Director's Hearing Regular Meeting Agenda: October 6, 2022

PUBLIC HEARING / QUASI-JUDICIAL. 601 Bryson Avenue [21PLN-00018]: Request for a Hearing on the Director's Tentative Approval of an Individual Review Application for Demolition of an Existing One-Story Home and Construction of a Two-Story Approximately 2,187.3 Square Foot Home With Detached Garage and an Attached ADU. Environmental Assessment: Exempt From CEQA in Accordance With Guideline Section 15303 (New Construction). Zoning District: R-1 (Single Family Residential). For More Information Contact the Project Planner Kristina Paulauskaite at kristina.paulauskaite@cityofpaloalto.org

Report Type:	Action Items	Meeting Date: 10/6/2022
Summary Title:	601 Bryson Ave: Director's Hearin	g for IR project
Title:	PUBLIC HEARING / QUASI-JUD [21PLN-00018]: Request for a Tentative Approval of an Indivi- Demolition of an Existing One-Stor a Two-Story Approximately 2,18 Detached Garage and an Att Assessment: Exempt From CEQA is Section 15303 (New Construction Family Residential). For More Info Planner Kristina kristina.paulauskaite@cityofpaloa	Hearing on the Director's dual Review Application for ory Home and Construction of 7.3 Square

601 BRYSON AVENUE BALCONY VIEWS ADDENDUM TO IR APPROVAL - 09/13/22 Packet Pg. 29

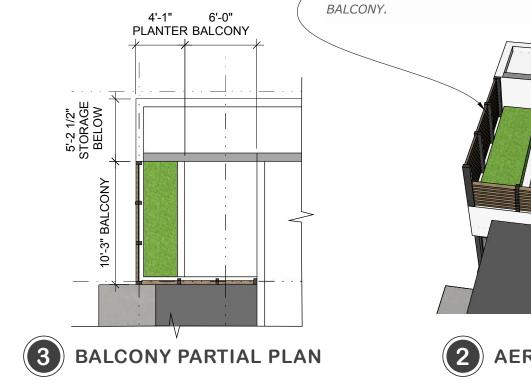
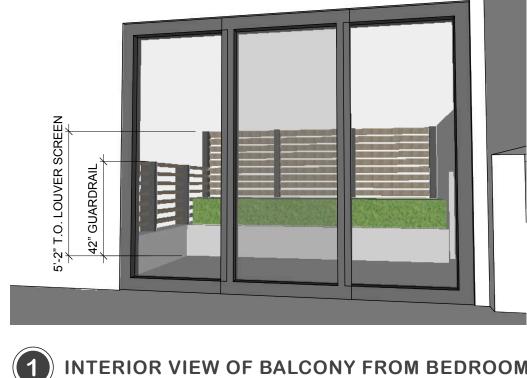
The back of our home includes two large windows/sliding doors that serve our master bedroom and living room. The proposed second story balcony/deck at 601 Bryson would provide broad views across the rear lot line directly into our master bedroom and into the living room, where we and our children spend the majority of our time.

The deck's size has been reduced in size about a third from the initial design but is still on the large size at 10 by 10 feet relative to most approved decks and would have views across the rear lot line, where it the neighbor at 2554 Webster Street has a house with rear wall glazed with large windows (see the photograph in the plan set).

On September 13, 2022, the project architect prepared a revised Renderings (Attachment H) which incorporated second floor deck screening solutions. The revised Renderings were emailed to both neighbors at 2554 Webster Street and the project planner.

- e. A new second floor deck screen shall be installed and maintained as shown on the approved plan set.
